Addendum No. 2

Issued:	September 15, 2023
Bids Due:	September 21, 2023
Project Name:	Renovate General's Quarters – Camp Rapid, B250
TSP Project No:	03221580
Owner Project No:	CFMO# 466501

AD101

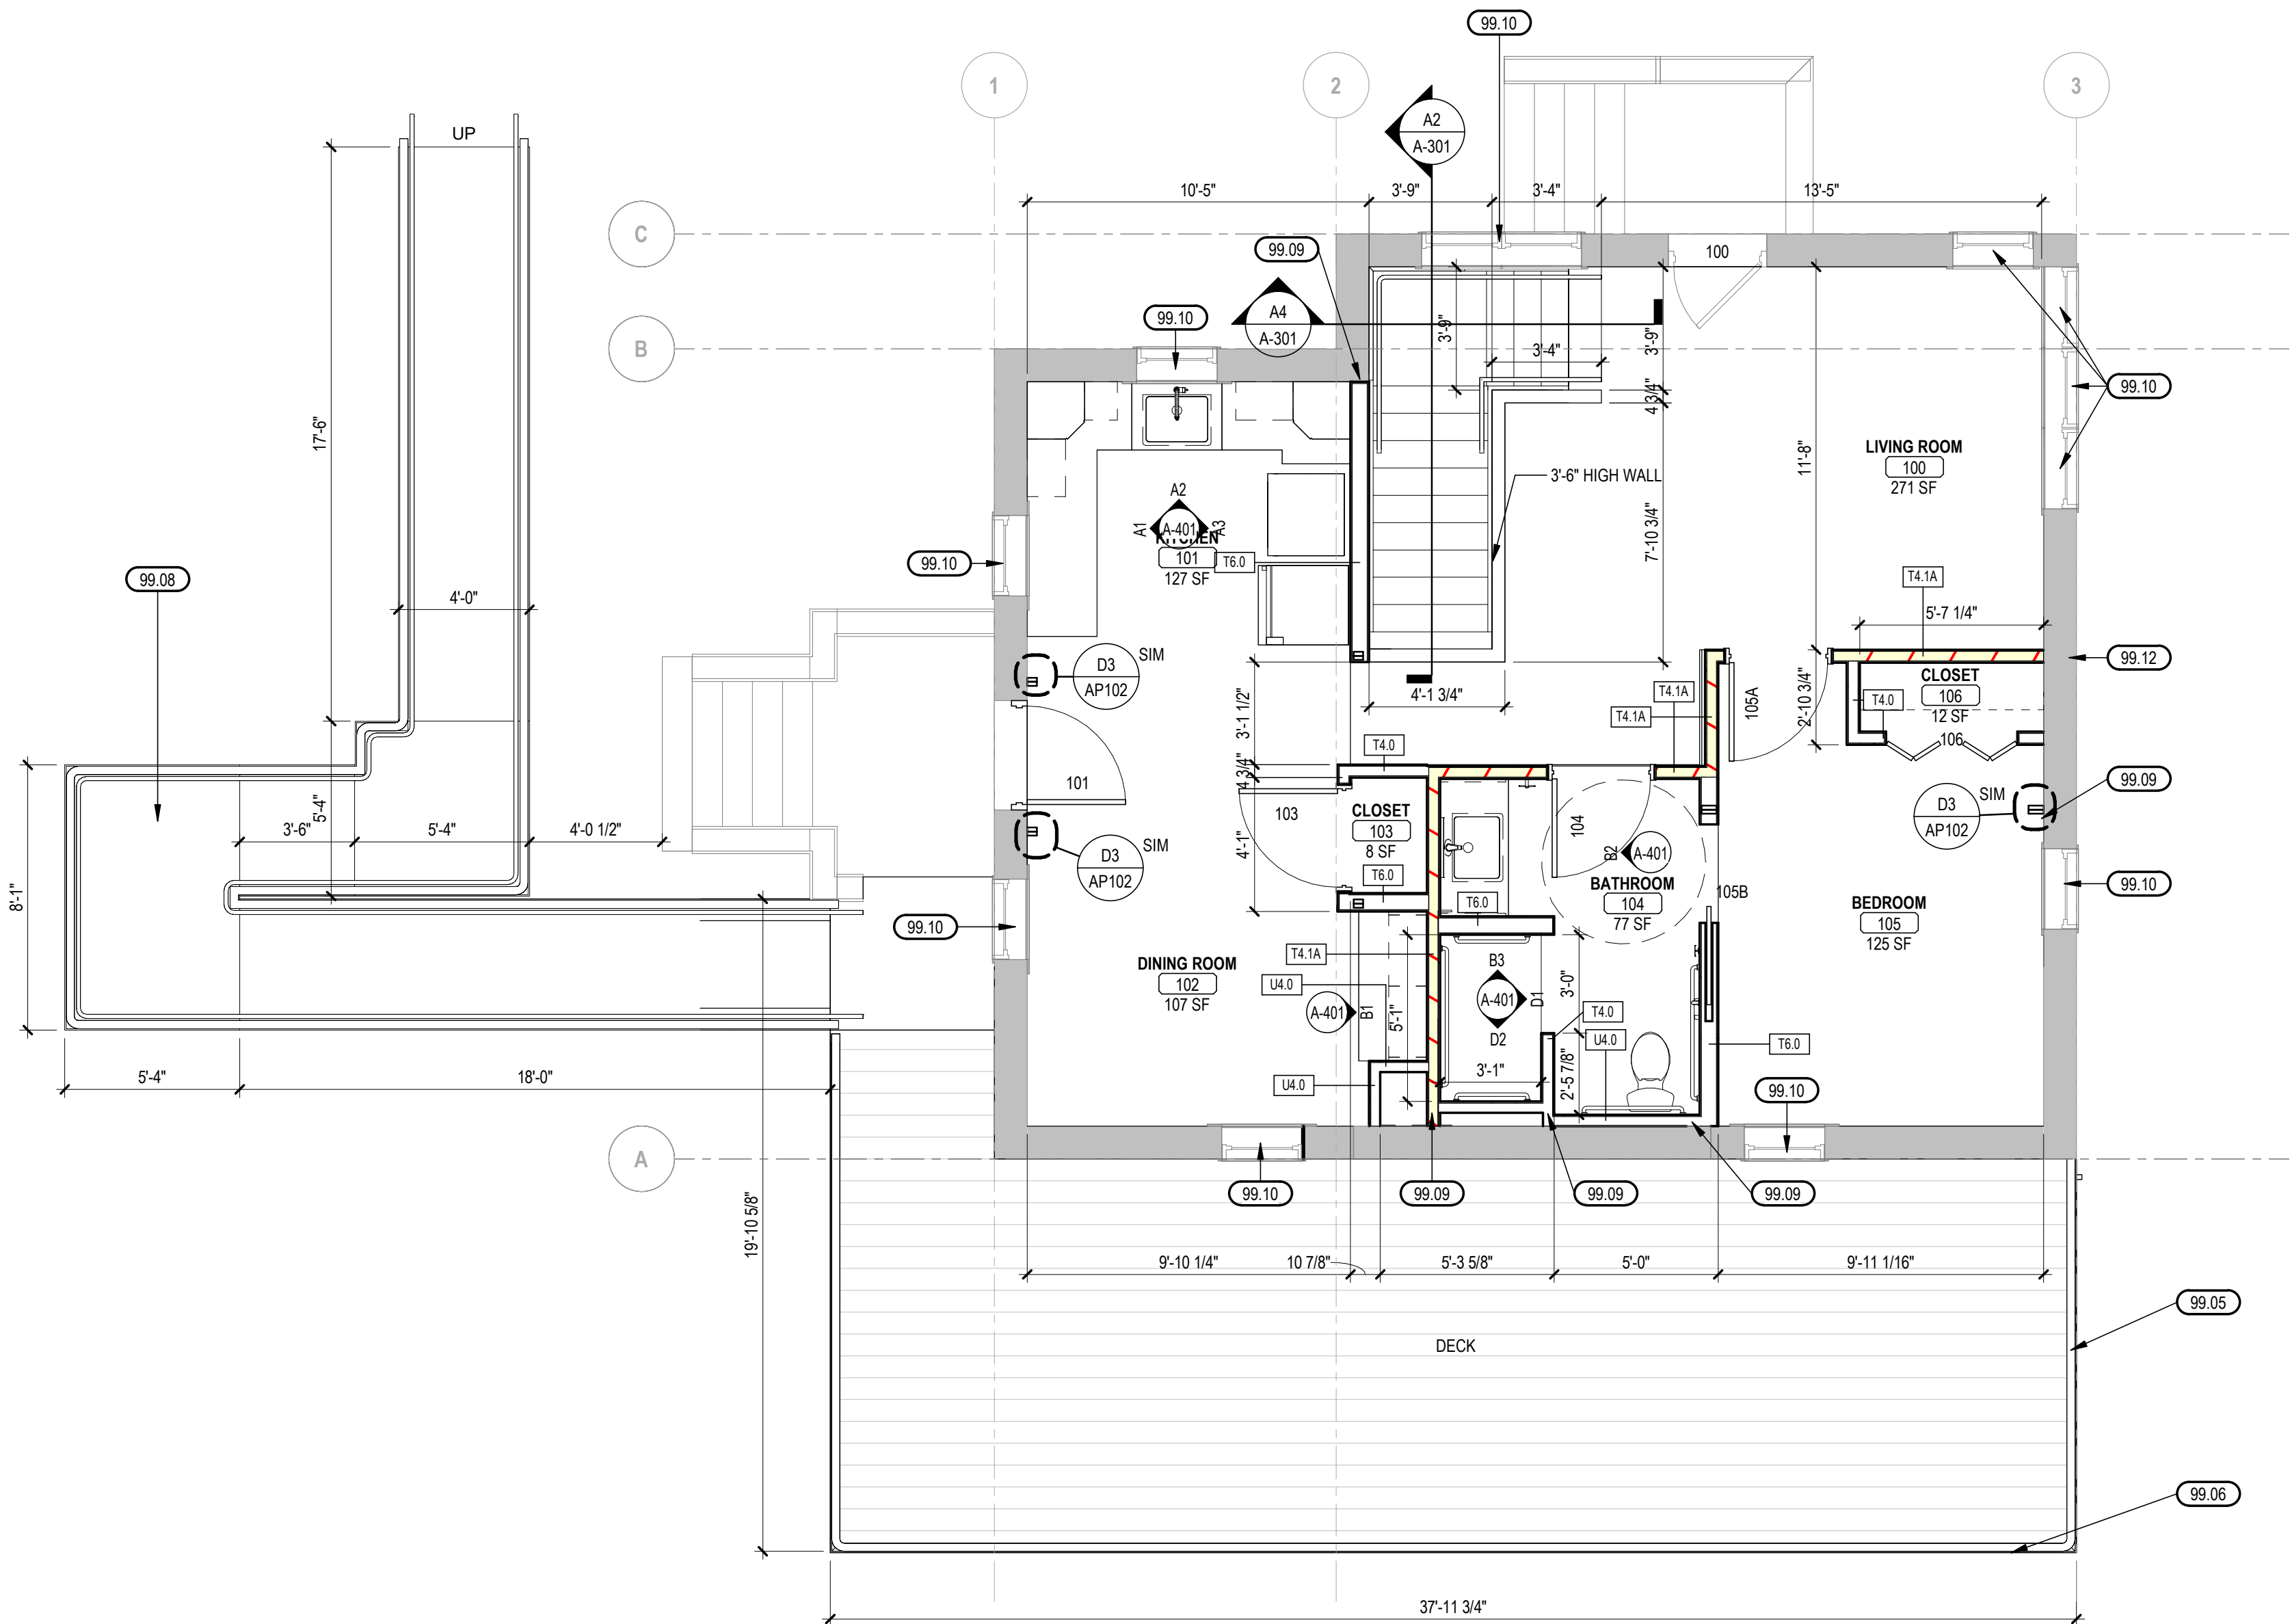
ITEM NO 2:	<u>AD101, Lower Level Demolition Plan:</u> Demo'd window infill where electricity enters the building. Fixed the keynote number for wall removal.

2.21	REMOVE CHIMNEY IN ITS ENTIRETY, INCLUDING ABOVE THE ROOF. NEW FAKE CHIMNEY TO BE INSTALLED AT THE ROOF.
2.22	REMOVE EXISTING WOODEN INFILL PANEL AND ELECTRICAL AS REQUIRED.

AP101

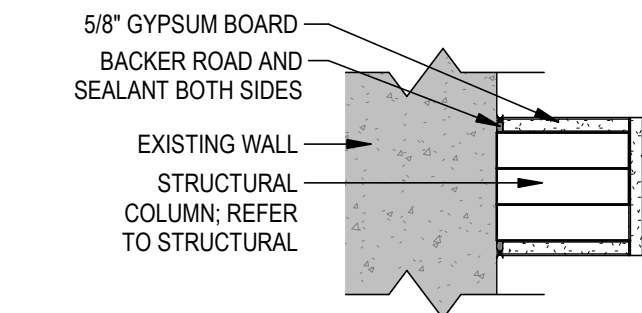
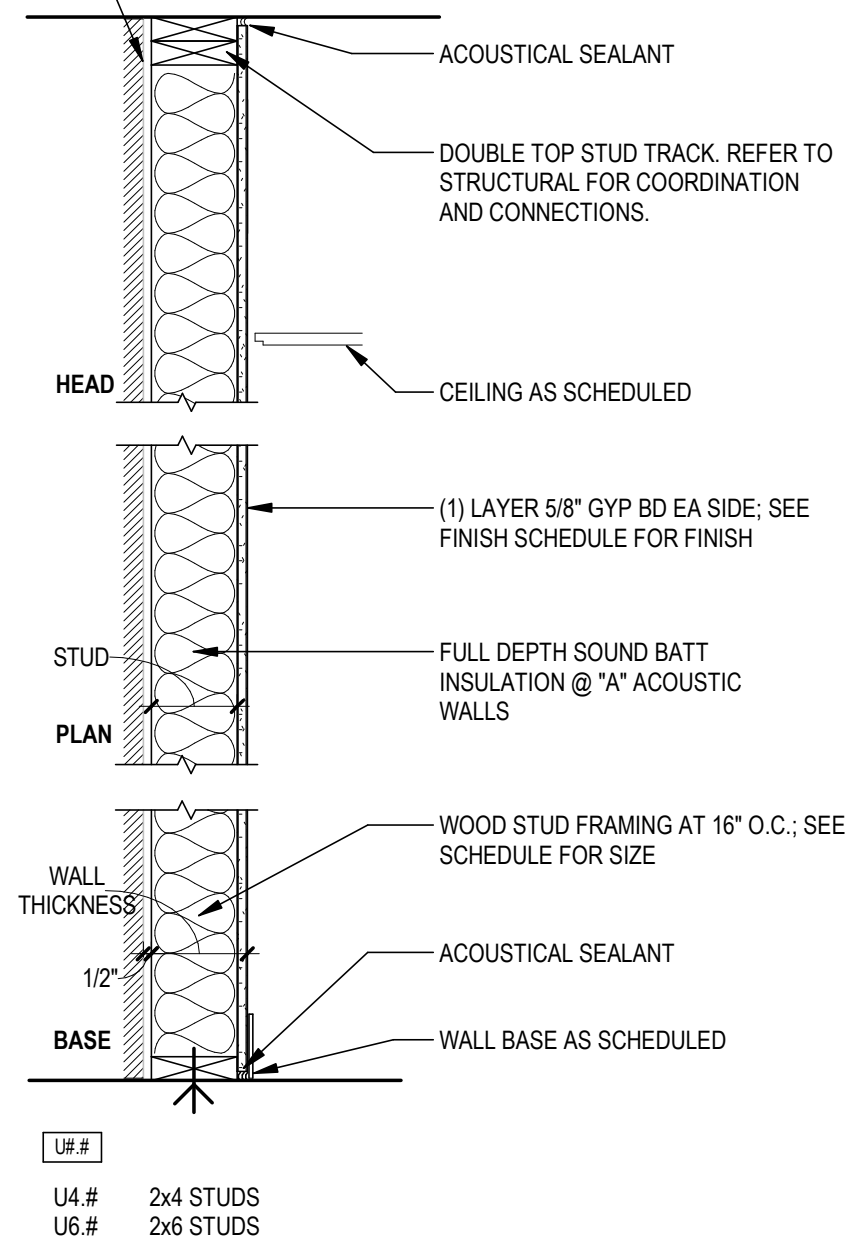
ITEM NO 3:	<u>AP101, First Level Floor Plan:</u> Removed the detail for the false chimney.
ITEM NO 4:	<u>AP102, Lower Level Floor Plan:</u> Indicated new infill where the wood window infill was.

AF101

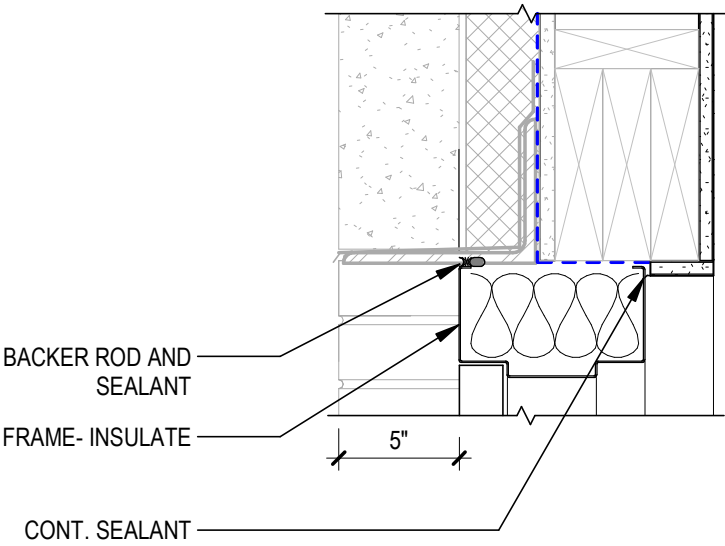
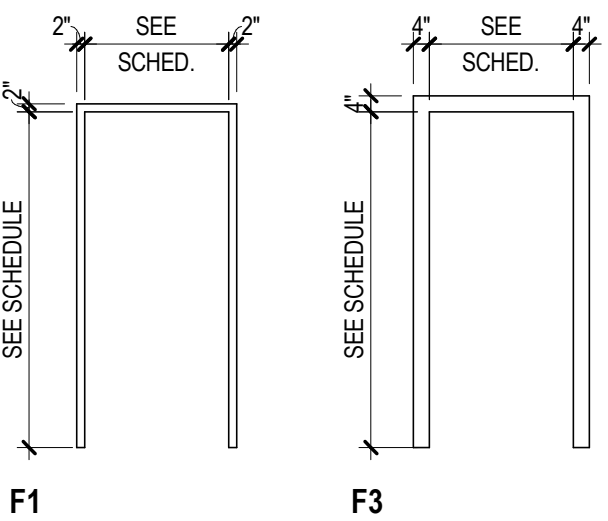
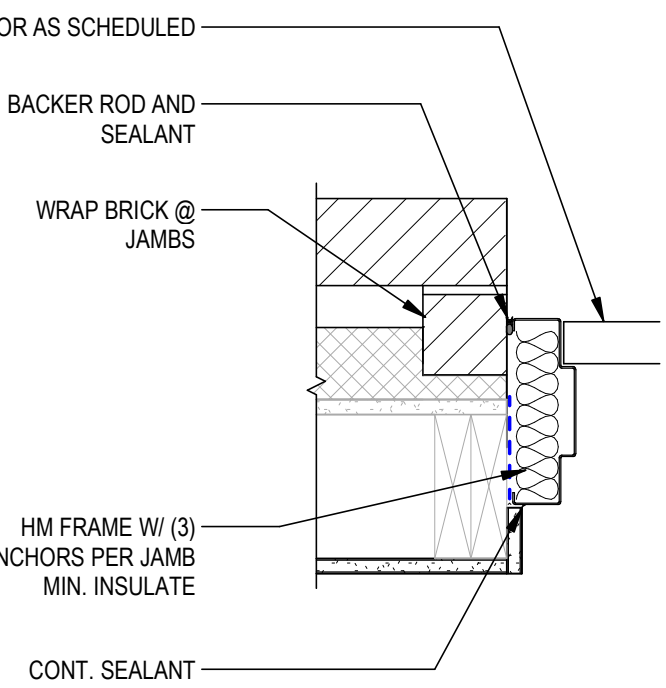
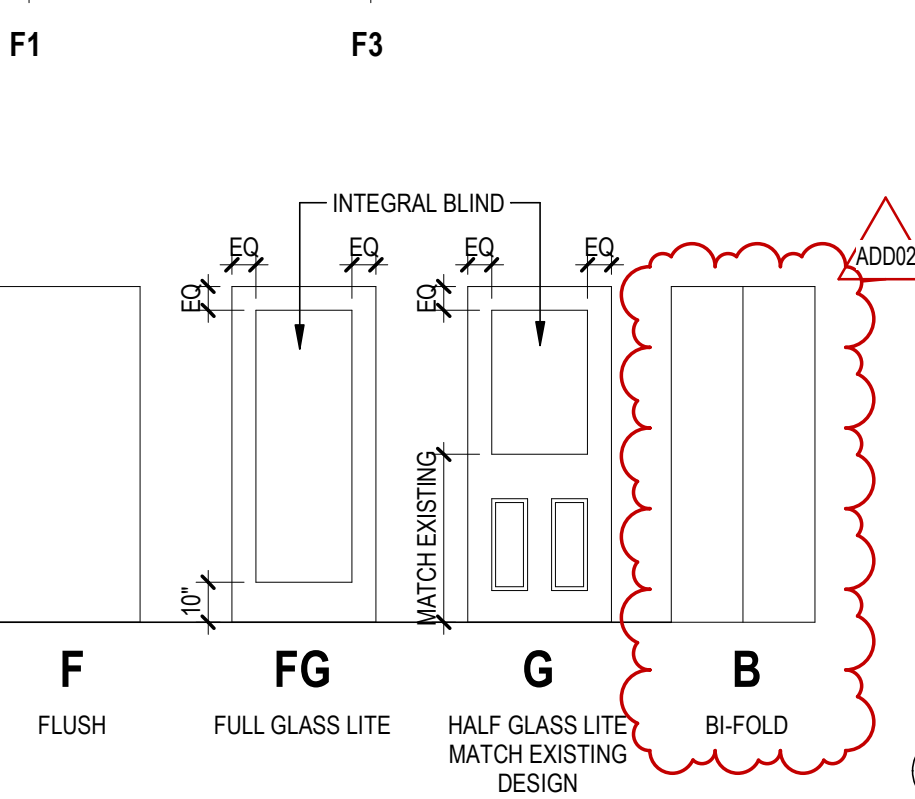
ITEM NO 5:	<u>AF101, Schedules:</u> Changed door type B to a flat front.
ITEM NO 6:	<u>ED101, Electrical Demolition Plan:</u> Demo'd the existing exterior receptacle on the plan east wall.

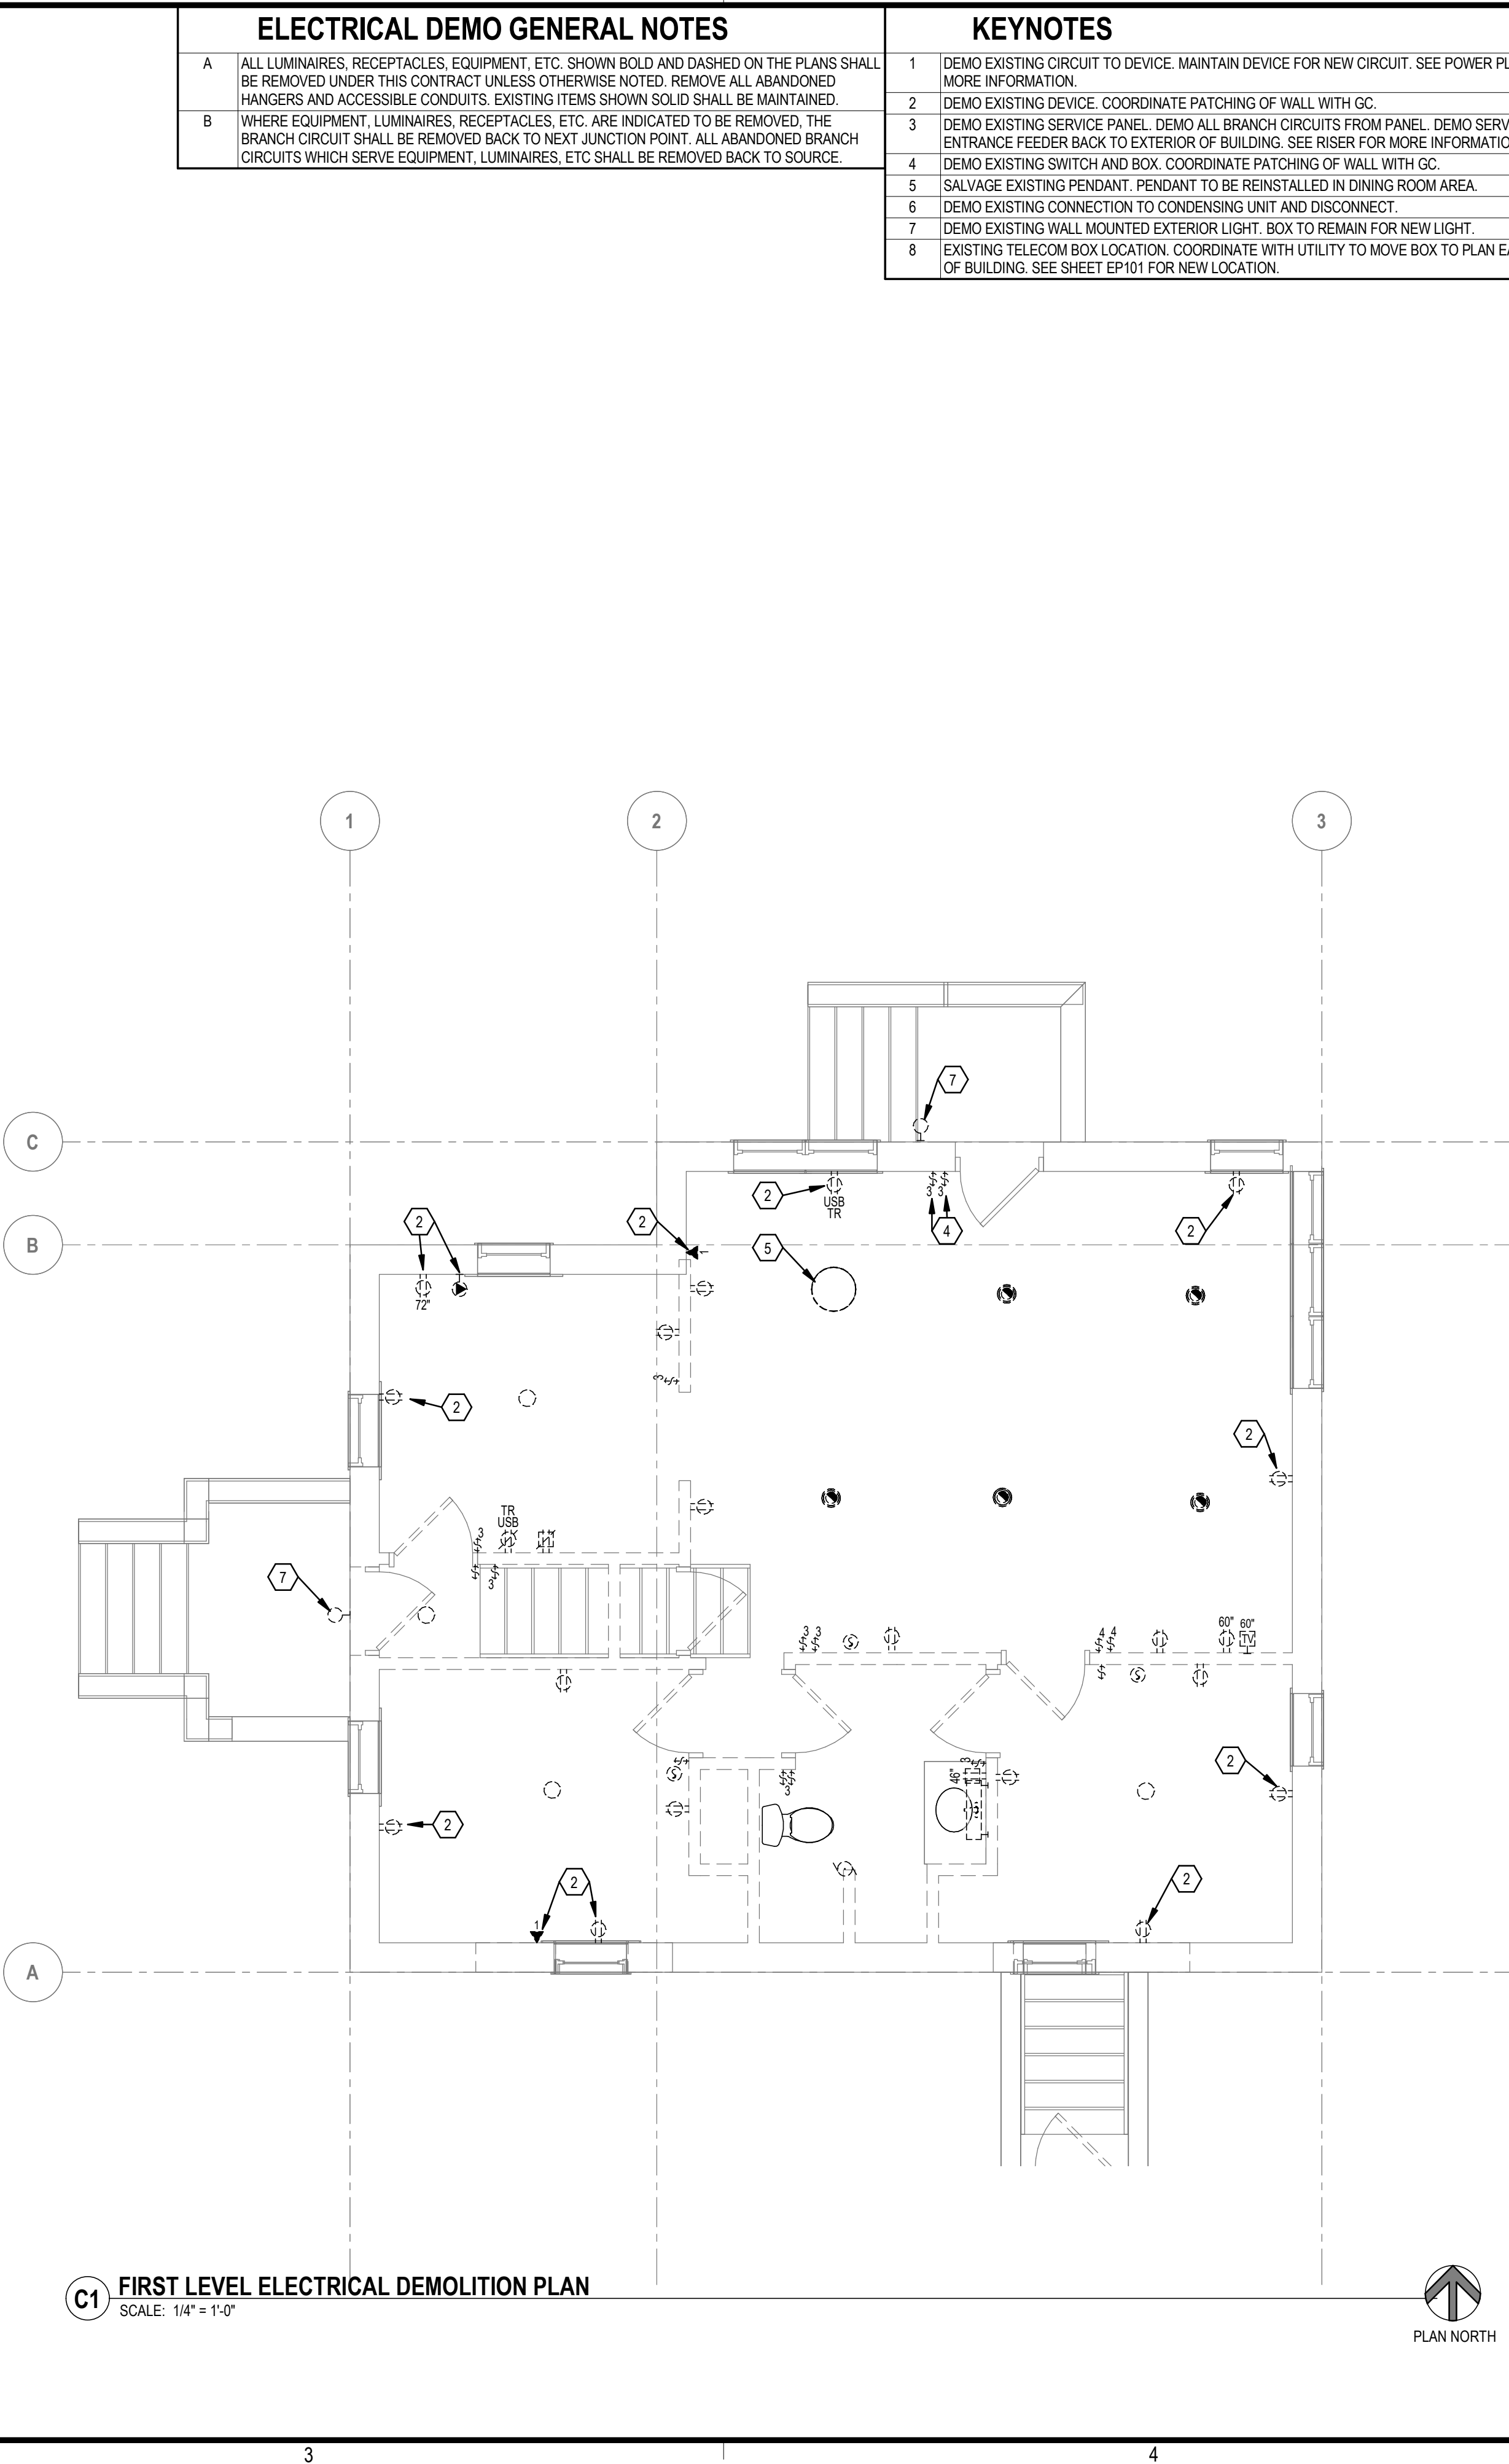
ITEM NO 7:	<u>EP101, Electrical Power Plans:</u> Provided a new exterior receptacle on the plan east wall. Receptacle to be mounted where wall is to be patched at the exterior.

7	ROUTE POWER AND COAX IN HALF WALL FROM BELOW.
8	PROVIDE CONNECTION TO FIRE ALARM TAMPER AND FLOW SWITCHES AS REQUIRED FOR FIRE SPRINKLER SYSTEM. COORDINATE REQUIREMENTS AND QUANTITIES WITH FIRE PROTECTION CONTRACTOR.
9	NEW SERVICE ENTRANCE DISCONNECT. SEE RISER FOR MORE INFORMATION.
10	PROVIDE A NEMA 14-30R RECEPTACLE FOR THE WASHER/DRYER UNIT. COORDINATE RECEPTACLE LOCATION SO THAT CORD IS ACCESSIBLE WHEN UNIT IS INSTALLED.
11	PROVIDE NEW CIRCUIT AS SHOWN TO EXISTING DEVICE.
12	RECEPTACLE FOR ELECTRIC RANGE. COORDINATE RECEPTACLE TYPE WITH RANGE BY OWNER.
13	PROVIDE COMBINATION SMOKE DETECTOR AND CARBON MONOXIDE DETECTOR.
14	PROVIDE SWITCH TO CONTROL EF IN BATHROOM.
15	RECESS FIRE ALARM DEVICE IN EXISTING WALL. COORDINATE CUTTING AND PATCHING OF WALL WITH GC.
16	PROVIDE 120V CIRCUIT TO RANGE HOOD.
17	NEW LOCATION FOR TELECOM BOX. COORDINATE WITH UTILITY FOR EXTEND ANY CABLING AS REQUIRED.
18	NEW RECEPTACLE TO BE MOUNTED WHERE EXTERIOR WALL WAS PATCHED AND FILLED IN.
